JAPAN comment on “ power fade”
Of HD Battery durability
@EVE55

26. April.2022

Battery Durability GTR for HD; Topics of battery power degradation (power fade)

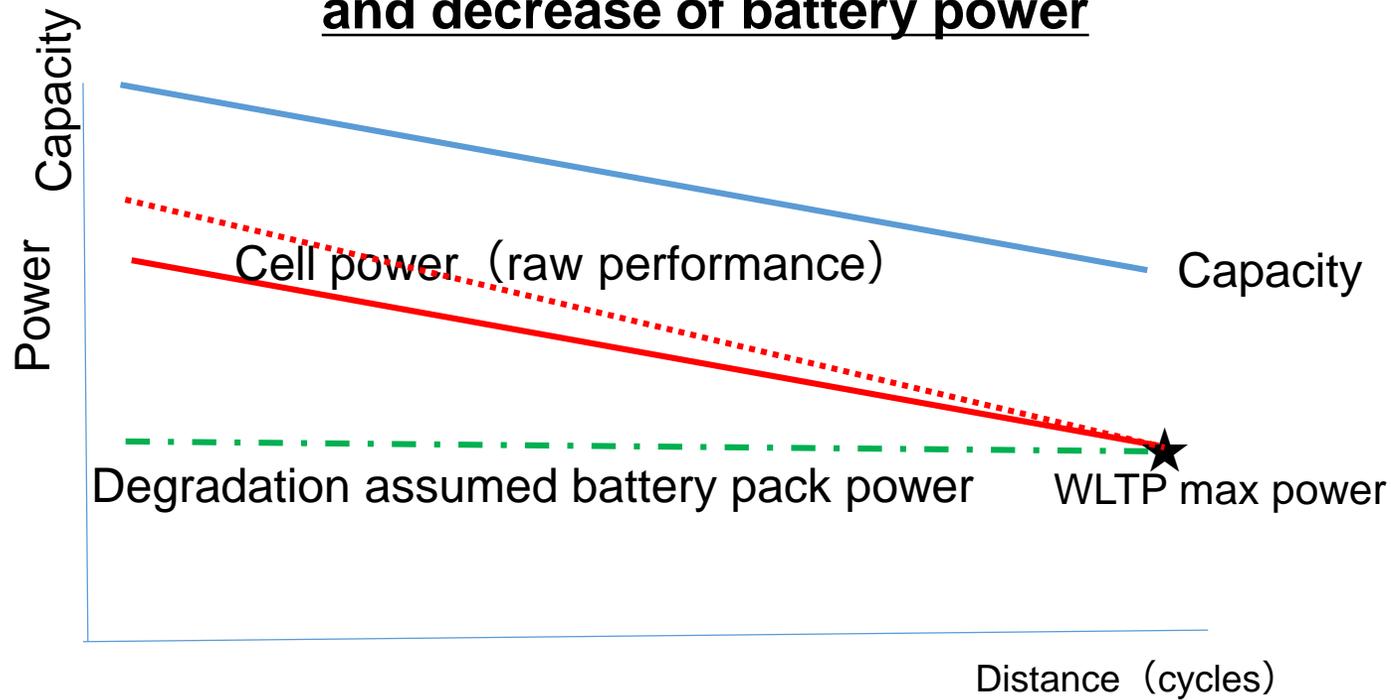
Do we develop the test procedure of in-vehicle battery power?

- Candidate 1: Peak power test under consideration by JRC
- Candidate 2: Revision of GTR 21

Correlation between degradation of capacity and decrease of battery power

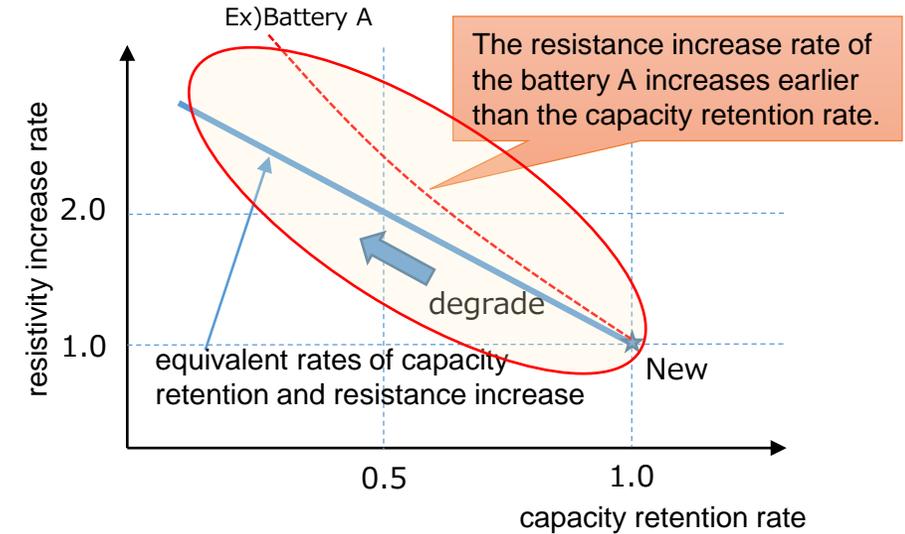
1. Correlation between capacity degradation and power degradation due to battery use (upper right)

There is a correlation that internal resistance also increases (= power decreases) as the capacity decreases, but the ratio is not likely to be the same (assuming that it varies depending on the battery specification).

The EV range is reduced due to a decrease in capacity, but there is no effect on the running power.

If **the output value is designed in the BMS based on assumed degradation**, there is no power fade from the certification.
